DESIGN <i>PH</i>	DRAWN BY <i>PH</i>	DART AEROSPACE LTD HAWKESBURY, ONTARIO, CANADA	
CHECKED <i>[Signature]</i>	APPROVED <i>[Signature]</i>	DRAWING NO. DSI 9297	REV. A SHEET 1 OF 1
DATE 05.03.15	TITLE CROSSTUBE MODIFICATION KIT		SCALE NTS
A	05.03.15	NEW ISSUE

DART SERVICE INSTRUCTION

TO AMEND INSTALLATION INSTRUCTIONS IIN-D212-664 REV. B

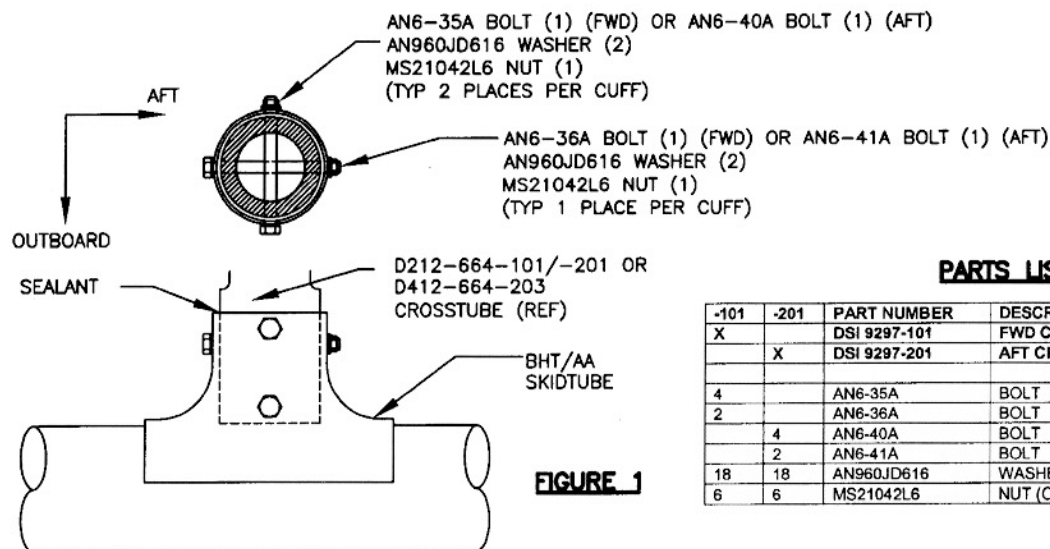
IT IS ACCEPTABLE TO PERFORM THE FOLLOWING MODIFICATION TO INSTALL DART
D212-664-101/-201 OR D412-664-203 CROSSTUBES AT CHG 001 ON THE FOLLOWING BELL/AA
(OR EQUIVALENT) SKIDTUBES (P/N 412-320-123/-124/-129/-130, 205-050-400-105/-106,
205-050-152-059/-060, 412-050-023-101/-102/-105/-106, 412-050-030-101/-102,
AND 412-050-043-101/-102 SKIDTUBES)

- 1) INSERT CROSSTUBE(S) INTO SKIDTUBE SADDLE(S).
- 2) PIN THE SADDLE(S) TO THE CROSSTUBE(S) USING THE AN6-35A/-40A BOLTS
- 3) TRANSFER DRILL 3/8" HOLES (4 PLACES) ON THE FWD AND AFT SIDES OF THE SADDLE TO THE CROSSTUBE.
- 4) OPEN HOLES IN CROSSTUBE(S) TO $\phi 0.386 \pm 0.005$.
- 5) REMOVE CROSSTUBE(S) FROM SADDLE(S), DEBURR DRILLED HOLES, TOUCH UP HOLES WITH MIL-P-85582 OR MIL-P-23377 PRIMER.

NOTE: ON EARLY MODEL BELL SKIDTUBES, THE FWD/AFT HOLES IN THE SADDLE(S) WILL ALSO HAVE TO BE OPENED TO $\phi 0.386$, DEBURRED, AND TOUCHED UP WITH PRIMER AS DESCRIBED IN STEP 5.

- 6) INSERT CROSSTUBE(S) INTO SKIDTUBE SADDLE(S). ENSURE SADDLE AND CROSSTUBE HOLES ARE ALIGNED. ATTACH THE CROSSTUBE TO THE SKIDTUBE SADDLE USING 4 AN6-35A/-40A BOLTS AND 2 AN6-36A/-41A BOLTS AS SHOWN IN FIGURE 1. ENSURE ALL BOLTS ARE FACING INBOARD OR AFT. ENSURE BOLT THREADS ARE NOT BEARING ON SADDLE SHEET. EXTRA AN960JD616 WASHERS MAY BE REQUIRED UNDER THE NUT TO ENSURE NUT DOES NOT START THREADING BOLT SHANK. TORQUE NUTS TO 110 IN-LBS.
